DESCRIPTIVE REPORT

Registry No. H-11024

General Locality Santa Barbara Channel

Sublocality Hueneme Canyon to Mandalay Beach

Chart 18725
26th Edition October 11, 1997
Scale Depicted: 1:50,000
Revisions from NOAA Hydrographic Survey H11024

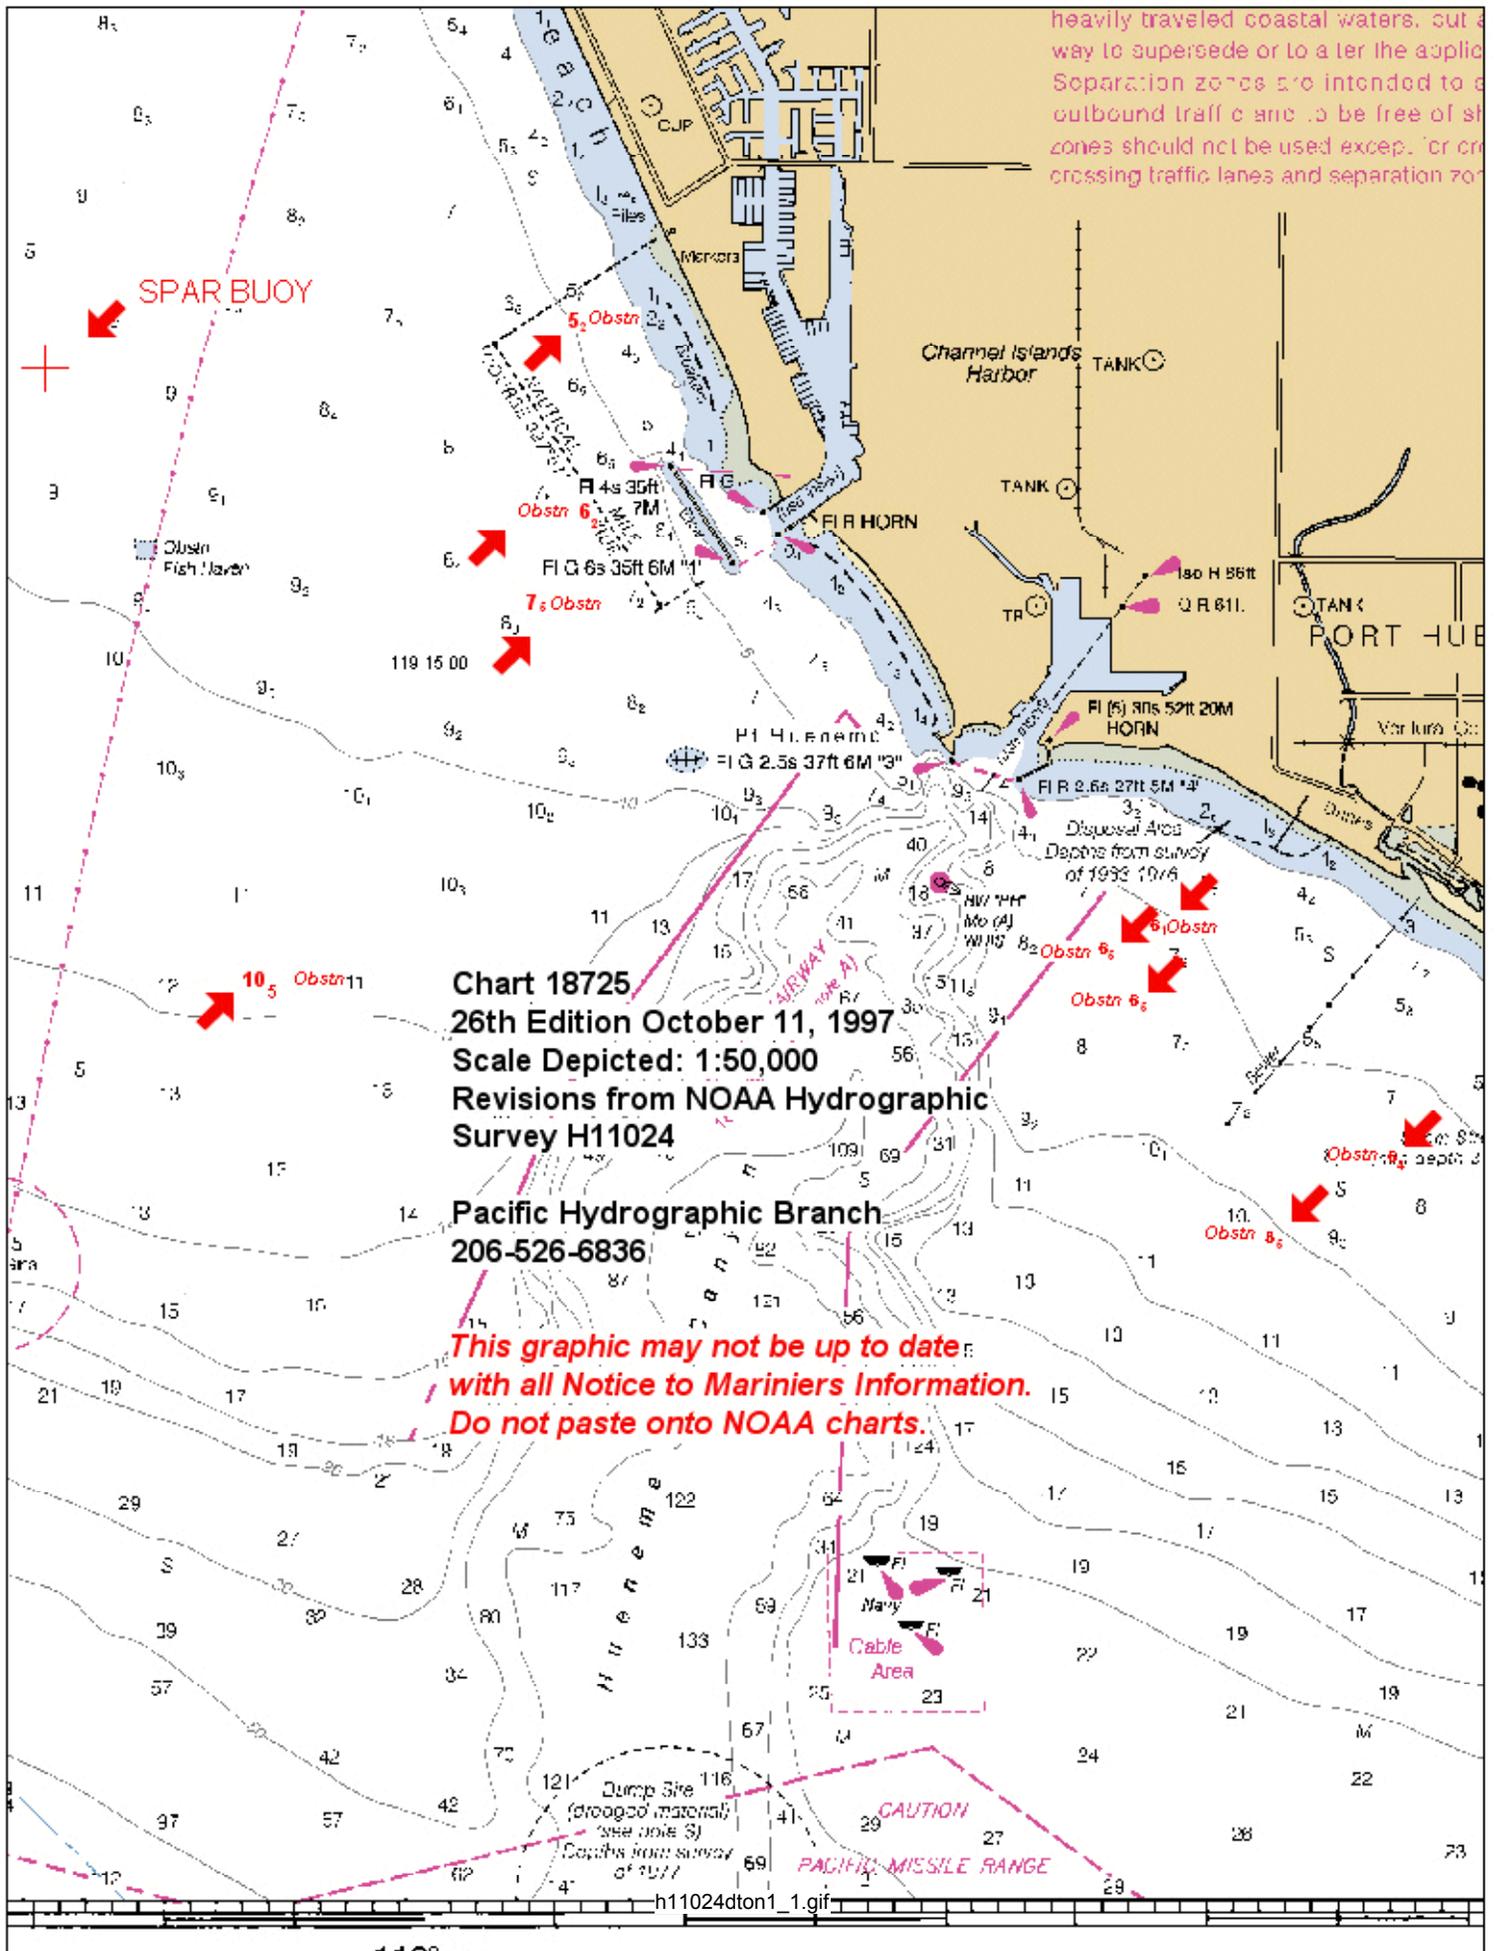
Chart 18725, 26th Edition, October 11, 1997, is a 1:50,000 scale chart and encompasses the entire survey area. The chart is in good agreement with the hydrographic survey, with some minor exceptions, and the Danger to Navigation Reports.

At the entrance to Channel Islands Harbor, a charted 5 fathom 2 feet sounding was surveyed at 4 fathoms 1 foot. Local Notice to Mariners No. 20 revised the 3 fathom 4 feet sounding, located off the western end of the breakwater at the northwest entrance, to 4 fathoms 4 feet, which matches surveyed depths. Southwest of this position 230 meters, a 3 fathom 0 foot sounding was surveyed. The main chart does not reflect this 3 fathom shoal but the inset does show a 3-fathom shoal in this location. The 3-fathom contour inshore of this area was surveyed 90 meters inshore of the charted 3-fathom contour.¹²

The reported minimum depth for the submerged structures off Ormond Beach of 3¼ fathoms was surveyed to be 2 fathoms 5 feet.

Hueneme Canyon was surveyed deeper than what is charted.¹³

A deepening trend can be seen southeast of the entrance to Port Hueneme along Ormond Beach. The 6-fathom contour was surveyed 280 meters inshore of what is charted, except over the charted sewer pipeline, where the contour is approximately 550 meters inshore.¹⁴

A shoaling trend can be seen northwest of Hueneme Canyon. The charted 10-fathom curve matches surveyed depths at Hueneme Canyon. Proceeding west, the surveyed 10-fathom contour migrates offshore from the charted 10-fathom contour to approximately 500 meters at the western limits of the survey. The charted 12-20, 30, 50 and 100-fathom contours match surveyed depths.¹⁵

The danger curve for the wrecks, northwest of the oil platform *Gina*, match the surveyed delineation with only minor adjustments required. The charted least depth of 10 fathoms 5 feet should be revised to 11 fathoms.¹⁶

¹² PHB Revision-concur, chart 4₁ fathoms sounding at latitude 34°09'38.73"N, longitude 119°14'03.32"W. Chart 3 fathom sounding at latitude 34°09'32.99"N, longitude 119°13'56.75"W

¹⁴ PHB Revision-concur

-
- ²⁴ PHB Revision-Concur, remove mooring buoys but the cable area note will be retained as charted.
- ²⁵ PHB Revision-Revise charted position of the oil platform *Gina* as shown on smooth sheet.

- ²⁶ PHB Revision-See AWOIS item 52714 for additional information.
- ²⁷ PHB Revision – Revised copies attached.
- ²⁸ PHB Revision-Area is located at latitude 34°07'44.6N, longitude 119°17'47.0"W. Revise area limits as shown on smooth sheet. Chart 13 fathoms at latitude 34°07'50.0"N, longitude 119°17'35.0"W.

- ²⁹ PHB Revision-Area is located at 34°08'05.6"N, longitude 119°17'43.9"W Chart 11 fathoms sounding at latitude 34°08'10.6"N, longitude 119°17'43.9"W. The 11 fathoms and 5 feet which should be charted as 12 fathoms was not charted due to the scale of chart.
Revise area limits as shown on smooth sheet.

- ³⁰ PHB Revision-Retain charted *Obstn Fish Haven*. Chart surrounding area as shown on smooth sheet.
- ³¹ PHB Revision-Delete *subm* wreck symbol located at latitude 34°08'39"N, longitude 119°13'59.5"W. Chart *7₅ Obstn* at latitude 34°09'09.54"N, longitude 119°14'35.29"W.

- ³² PHB Revision-Revise alignment of charted outfall as shown on smooth sheet. Chart observed pipeline as shown on smooth sheet.
- ³³ PHB Revision-Chart buoys at survey locations. Revise charted note to reflect *Subm Structures (2 fathoms 5 feet)*.

- ³⁴ PHB Revision-concur, delete lighted mooring.
- ³⁵ PHB Revision-Revise charted platform *Gina* to the surveyed position of latitude 34°07'03.06"N, longitude 119°16'37.56"W.
